AGENDA
PORT AUTHORITY
WEDNESDAY, JANUARY 7, 2026
CITY HALL COUNCIL CHAMBERS
4:00 PM

Re: Change Order request - 117 1st Avenue NW (Sync Health / Terry Hall)

The purpose of this memo is to outline newly discovered building conditions affecting the BEEP-funded exterior improvement project at 117 1st Avenue NW and to request that the Port Authority Board consider whether a change order to the previously approved project and funding amount is warranted.

Project: SYNC Date: 12-9-25

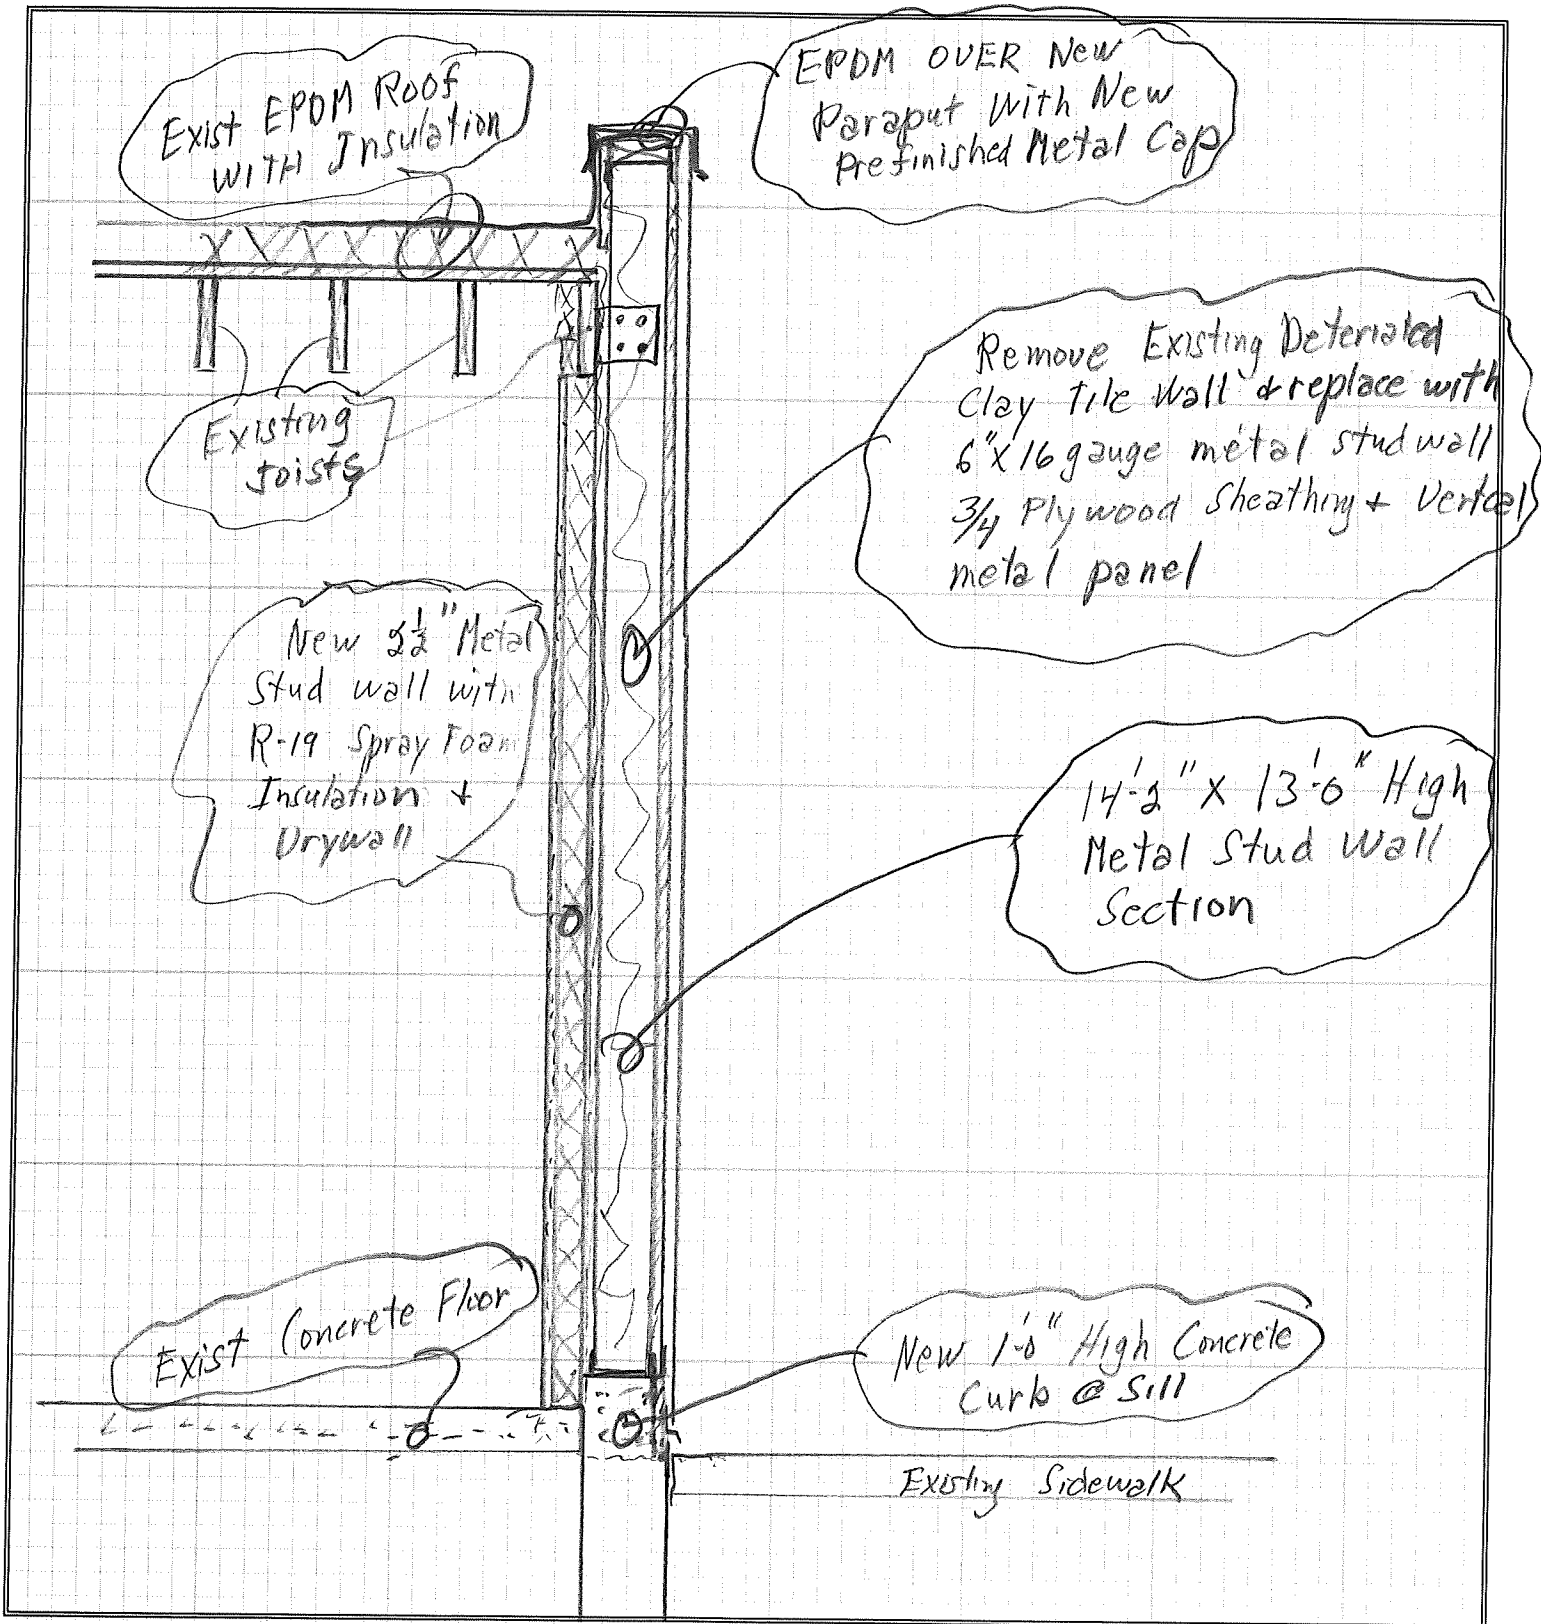
After construction began and the exterior plastic brick veneer was removed, the project team discovered previously concealed wall conditions that could not have been identified prior to Board approval. Specifically:

- Large portions of plaster assumed to be intact were found to be significantly deteriorated.

- The underlying clay tile wall was discovered to be crumbling and structurally unsuitable to support the approved exterior façade system.

The contractor has submitted a change request totaling \$14,450 to address the unforeseen condition. Under the standard BEEP 50/50 structure, the Port Authority share would be \$7,225, with the remaining 50% paid by the property owner.

- Remove the compromised clay tile wall as necessary,
- Expose existing interior spray foam insulation, and
- Construct a new exterior framed wall system capable of supporting the approved exterior improvements.
